BUILDING INSPECTION PERMIT

Permit Number: 040791

AT 165 St John St

Proposed Project Description:
22' x 30'

165 St. John St.

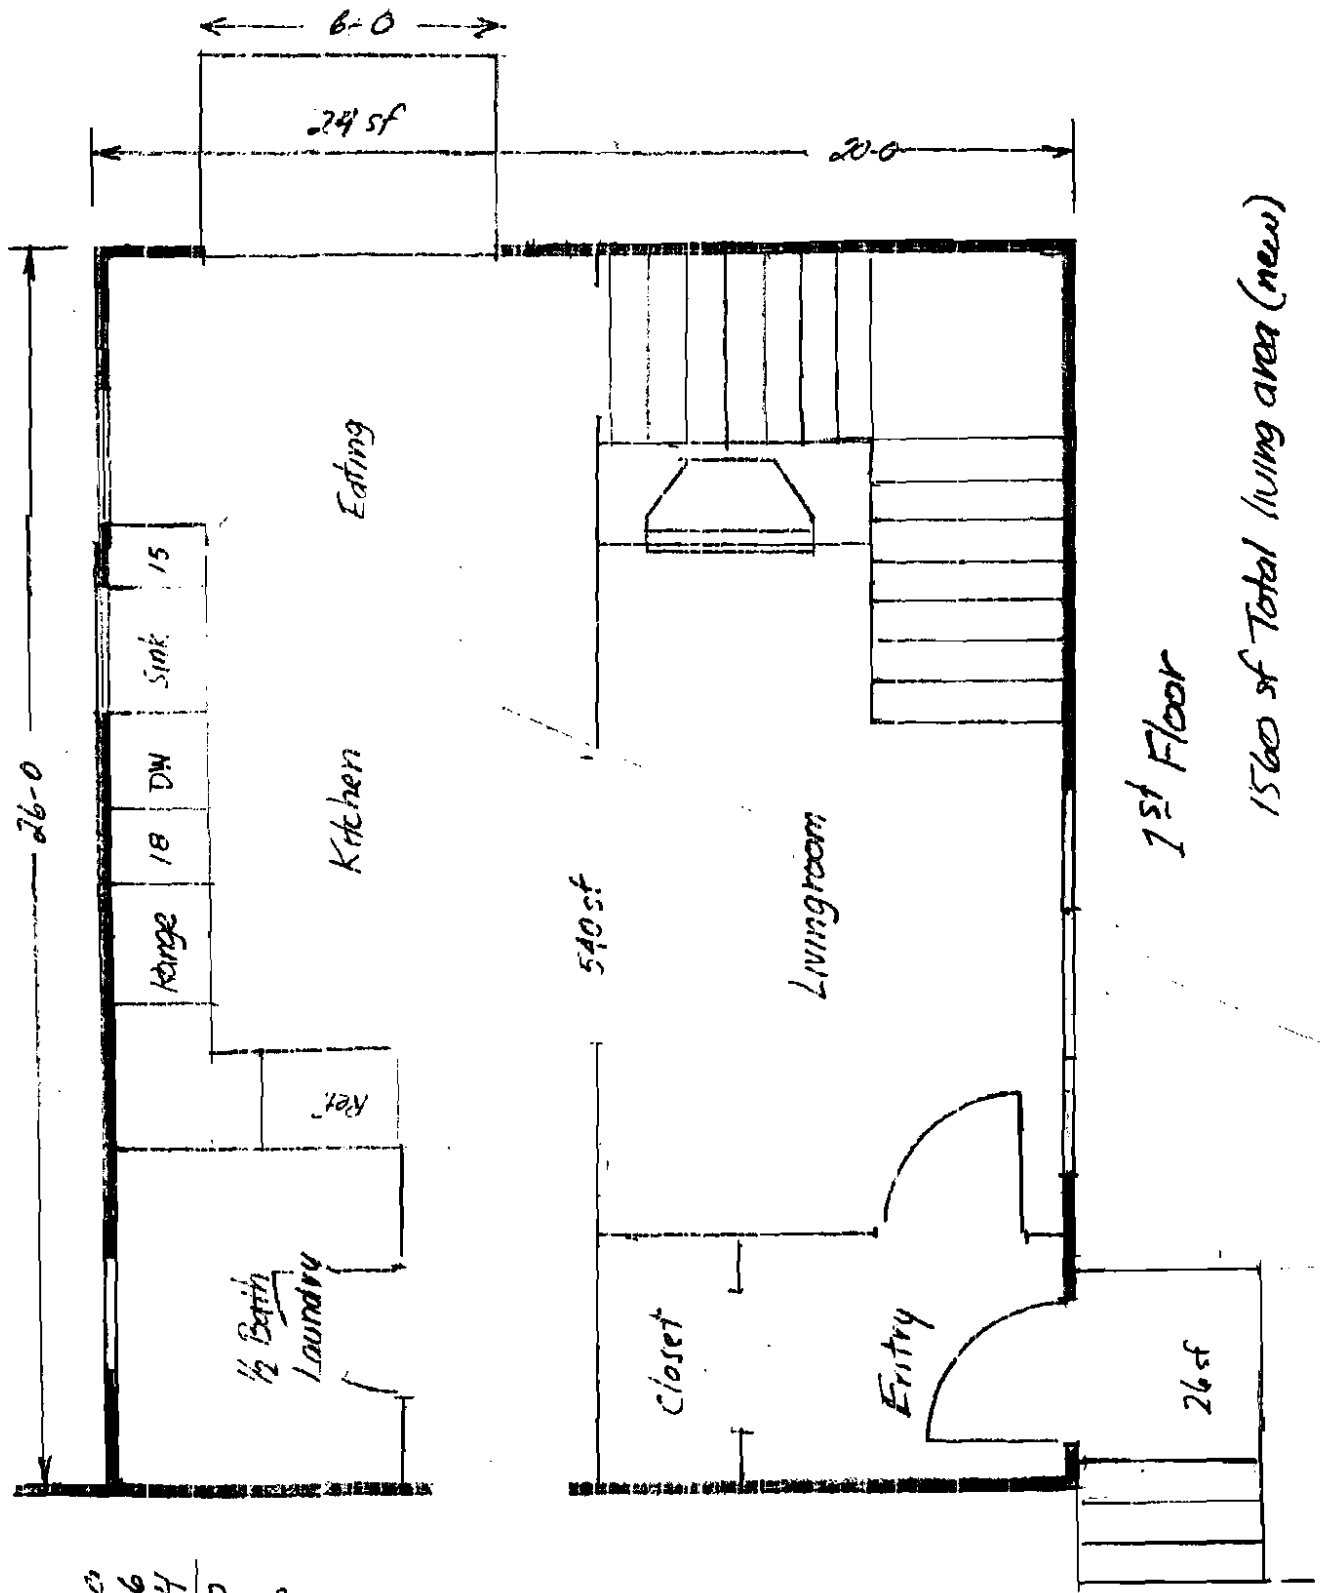
Soil type/Presumptive Load Value (Table 401.4.1) _____		
STRUCTURAL		
Footing Dimensions/Depth (Table 403.1.1 & 403.1.1(1), Section 403.1.2)	8"x16"-OK	
① Foundation Drainage Damp proofing (Section 406)	Not shown	
Ventilation (Section 409.1) Crawls Space ONLY	N/A	
② Anchor Bolts/Straps (Section 403.1.4)	size ?	
Lally Column Type, Spacing and footing sizes (Table 502.3.4(2))	OK	
Built-Up Wood Center Girder Dimension/Type (Table 502.3.4(2))	OK	
Sill/Band Joist Type & Dimensions	OK	
First Floor Joist Species Dimensions and Spacing (Table 503.3.1(1) & Table 503.3.2(1))	2x8's	
Second Floor Joist Species Dimensions and Spacing Table(503.3.1(1) & Table 503.3.2(1))	2x8's

Attic or additional Floor Joist Species Dimensions and Spacing (Table 802.4.2 or 503.3.1(1) & Table 503.3.2(1))	OK trusses	
Roof Rafter Pitch, Span, Spacing & Dimension (Table 802.3.2(7))	OK	
Sheathing; Floor, Wall and roof (Table 503.2.1(1))	OK	
Fastener Schedule (Table 602.3(1) & (2))		
Private Garage Section 309 and Section 407 1999 BOCA) Living Space ? (Above or beside)	N/A	
Fire separation		
Fire rating of doors to living space Door Sill elevation (407.5 BOCA)	N/A	
③ Egress Windows (Section 310)	4060's shown - meet's egress?	
Roof Covering (Chapter 9)	OK	
④ Safety Glazing (Section 308)	Need bath layout of 2nd floor	
⑤ Attic Access (BOCA 1211.1)	Not shown	
⑥ Draft Stopping around chimney	" "

7	Header Schedule	Not shown	
8	Type of Heating System	Not shown	
	Stairs Number of Stairways		
	Interior 1		
10	Exterior 1 - Tread/Rise not shown		
	Treads and Risers (Section 314) Interior - 10" T & 7 ⁵ / ₁₆ " R - OK		
	Width OK		
9	Headroom Not shown		
11	Guardrails and Handrails (Section 315) Not shown on exterior		
12	Smoke Detectors Location and type/Interconnected	Not shown	
	Plan Reviewer Signature

TY? **CROSS-SECTION**

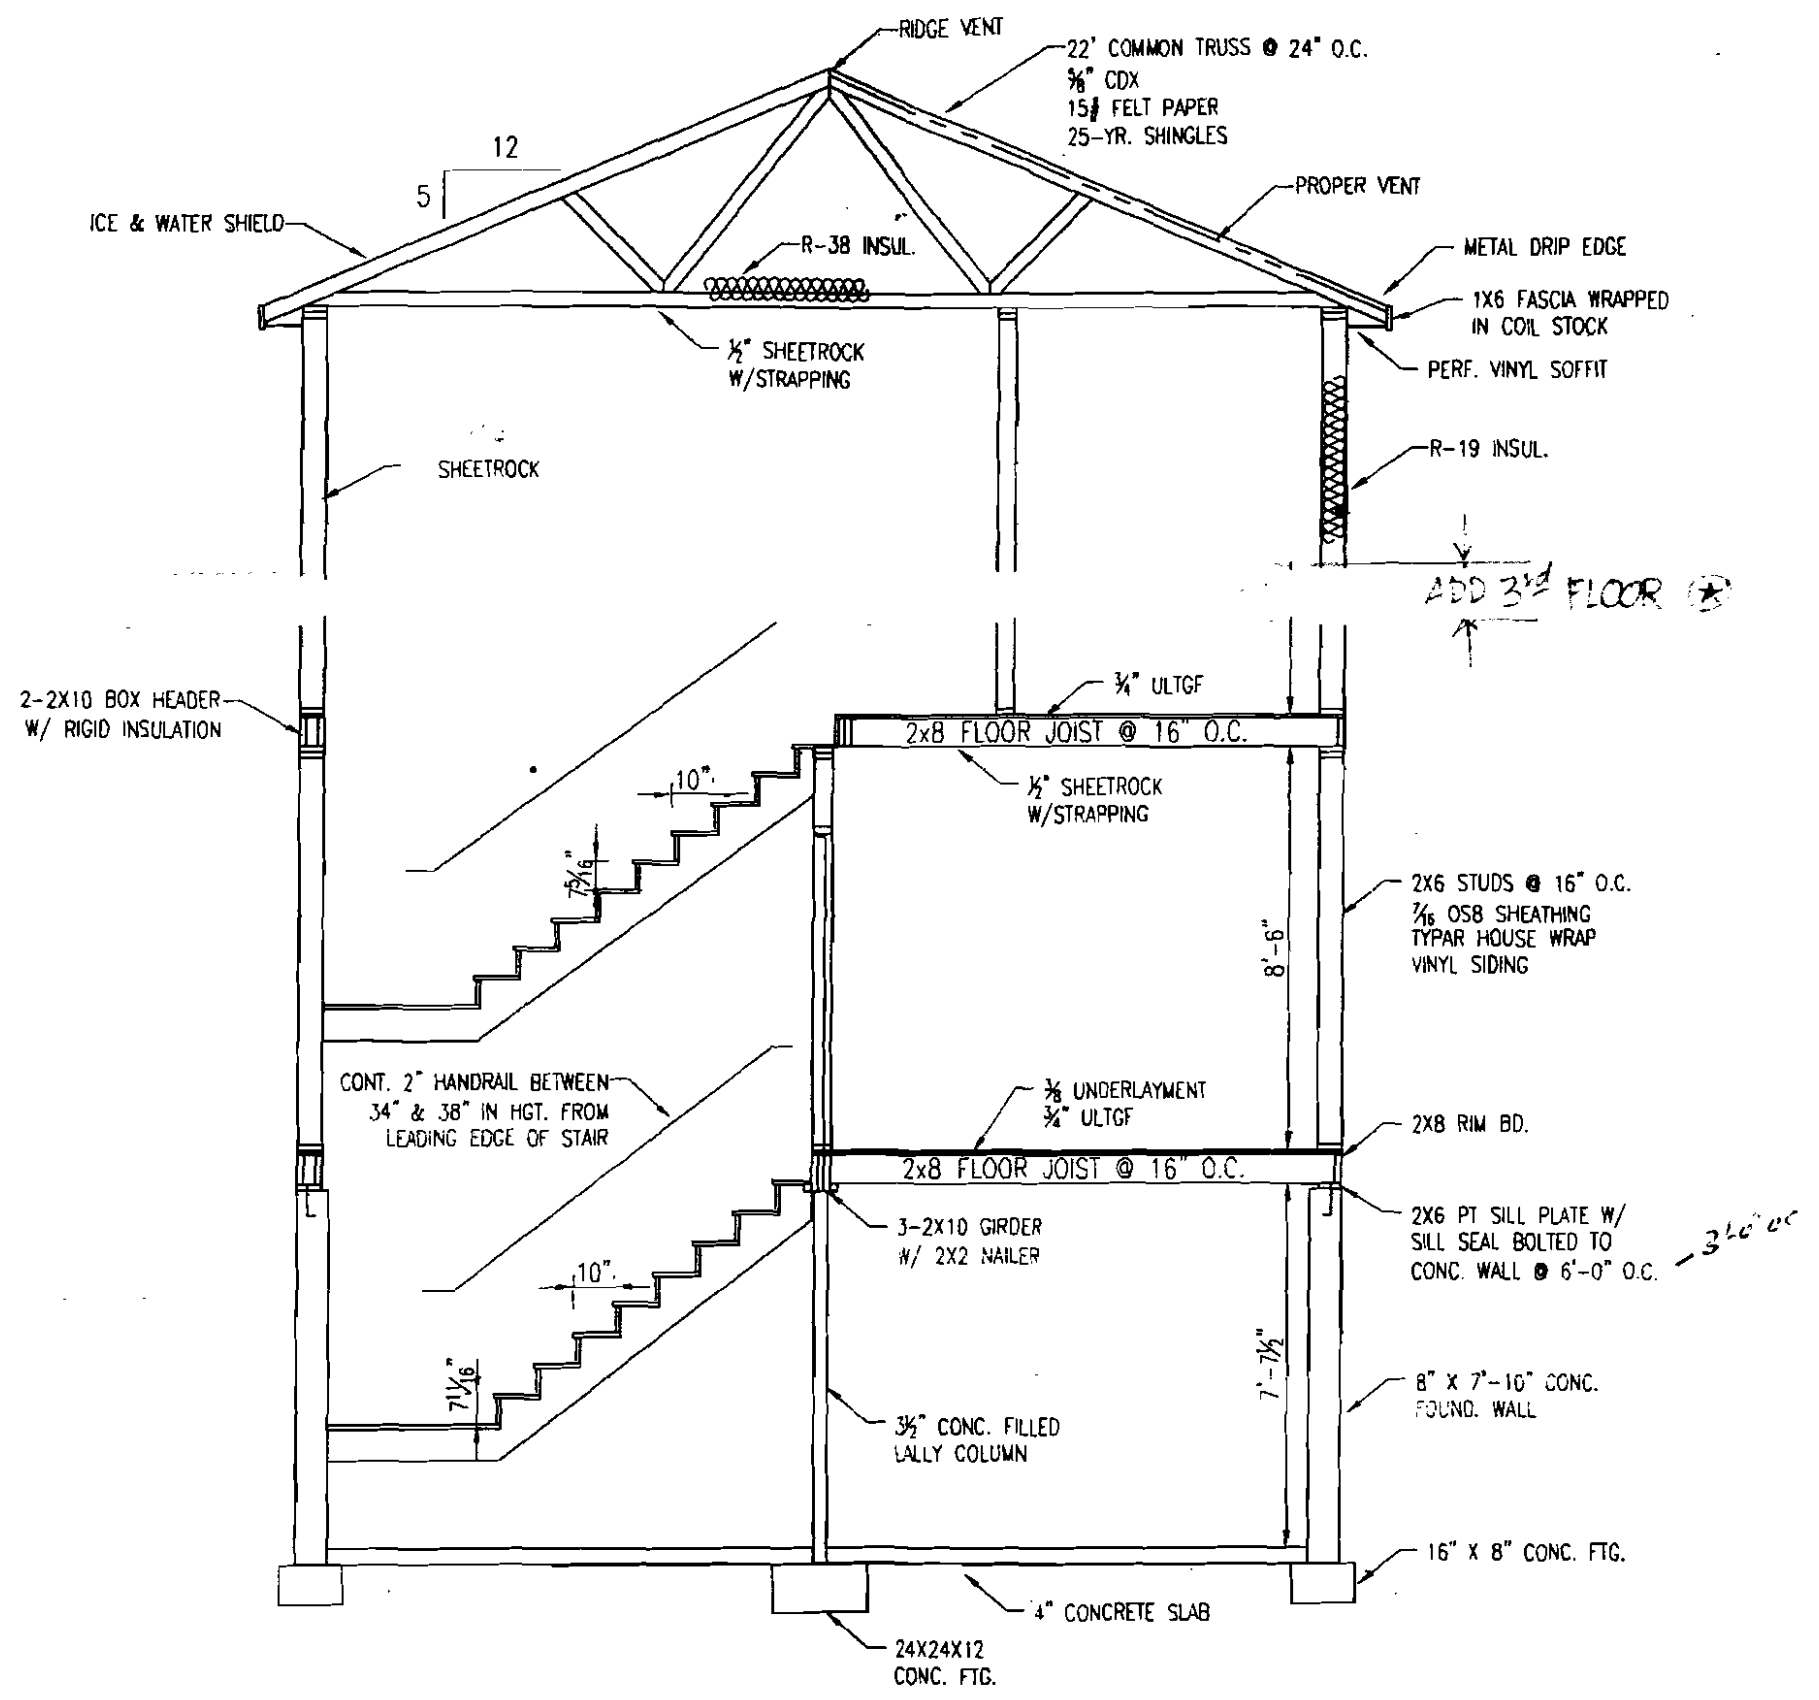
1. The scuttle access must be a minimum of 22" x 30".
2. Draft stopping must be installed at every level including the roof of 26 gauge metal and the chimney must be a minimum of 2" from combustibles.
3. There is a 6'-0" opening in the bearing wall. What is the beam size?
4. How will the exterior decks be framed?

1. We will make the scuttle access 22 x 30. I suspect that a full size opening did not appear on the original set of plans because it called for a 4/12 pitch truss system and typically we don't see a full-size scuttle cut into a system where there is no usable space to access. We will probably locate the scuttle in the smallest closet in the Master bedroom (adjacent to the chaseway for the gas fireplace venting). I will make that notation on my copy of the plans.

FIRST FLOOR PLAN

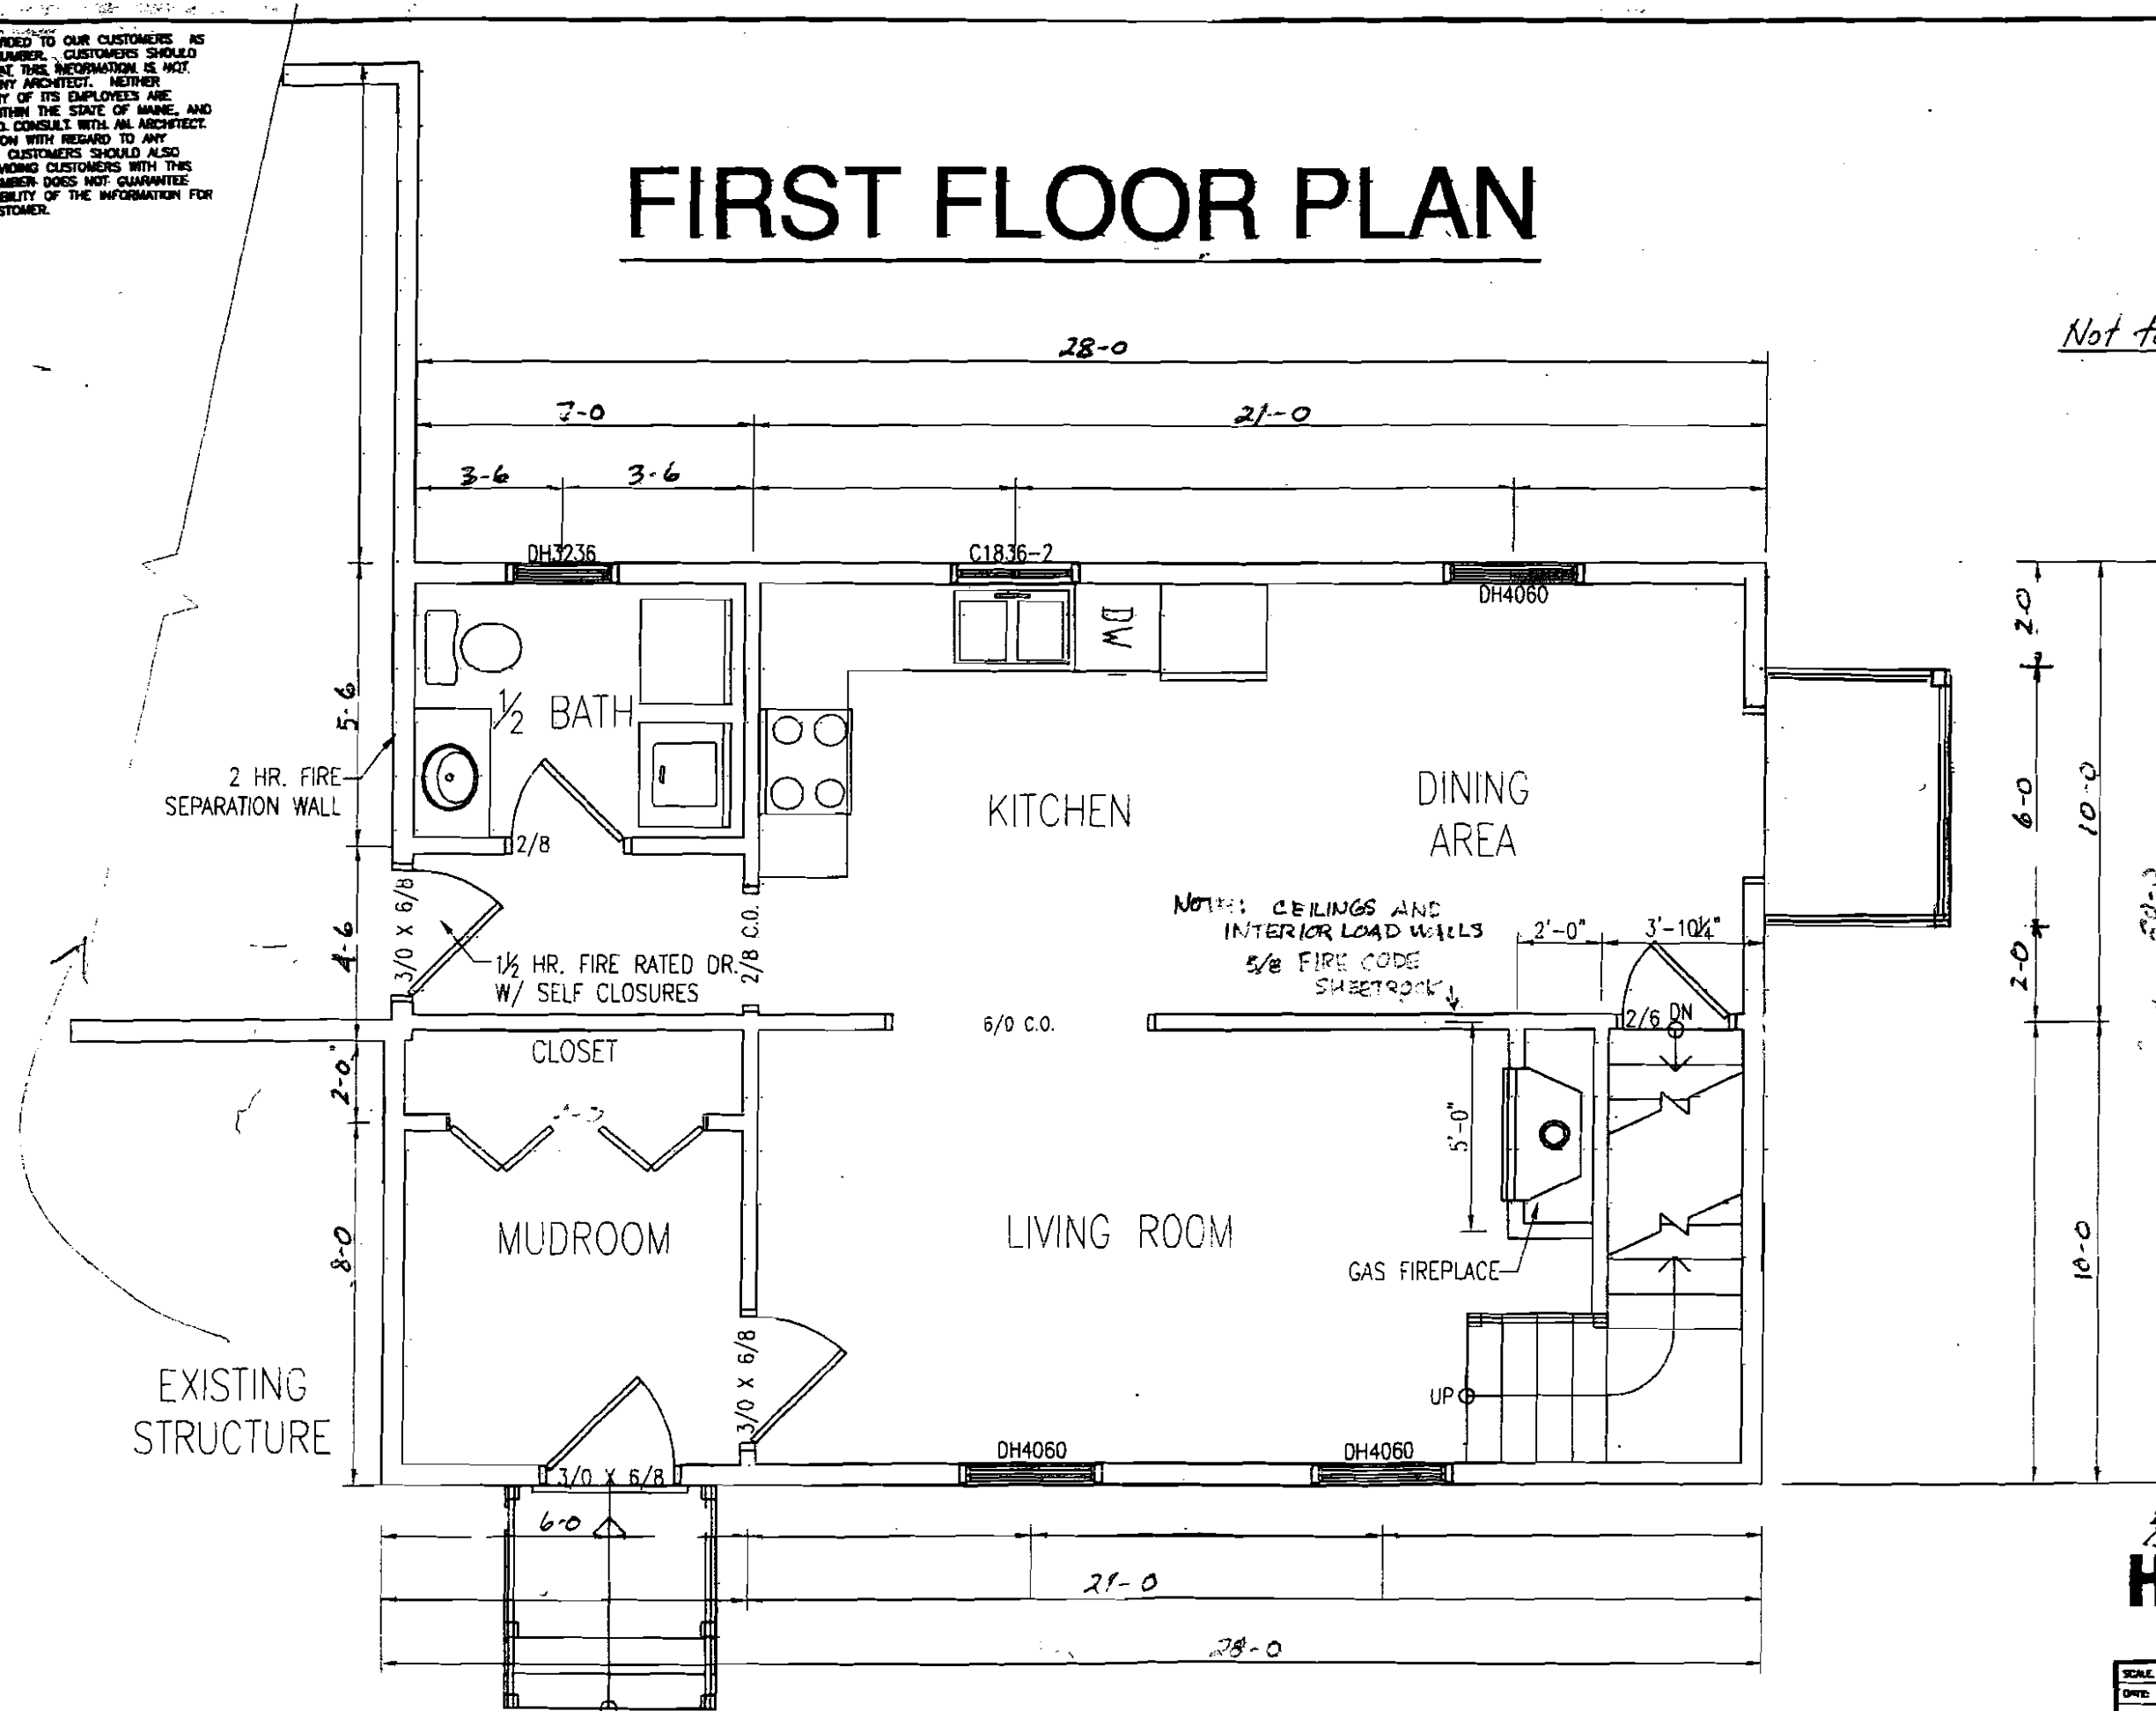
10/1/04-tmm: rec'd plans 09/27/04 - still need to know how exterior stairs will be framed and header over 6' opening carrying 2 floors above. Zoning issues resolved. Spoke w/builder regarding this.

3. It is unclear what the beam size is on the Hancock plan. I would guess that it would be three 2x10's sistered to form a girder (same as identified in the cellar), however, the drawing looks like an LVL but there are no written specifications. I will request a response from them but, for now, will pencil in the three 2x10 spruce until then and triple-up on the studs directly above the kings and jacks of that opening thereby reducing any load that may be an issue. The header size is 2x6 with jacks @ 16" OC. There should be no problem with load there. Hope this is sufficient response.

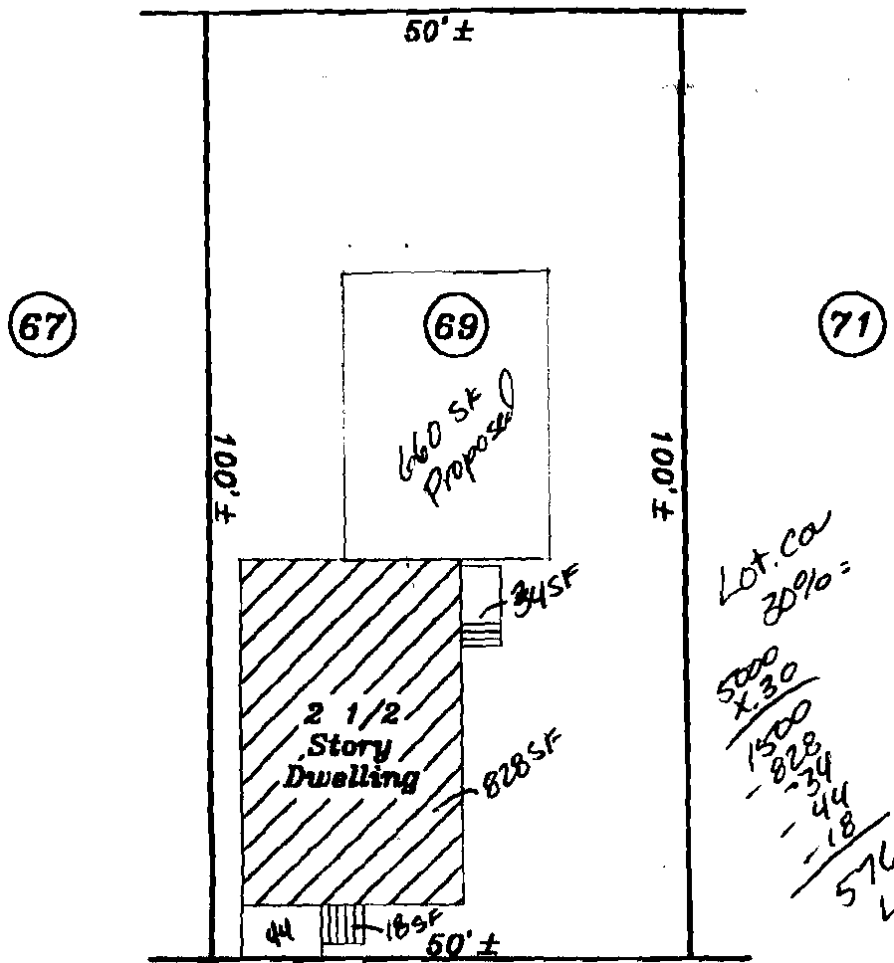
*R-4
 Front - Rear - 25'
 Side - 1 story 10'
 2 story 14'
 Lot cov. 30%*

*Lot. cov 20% =
5000 x .30 = 1500
- 828 = 672
- 16 = 656
- 44 = 612
576 SF LEFT.*
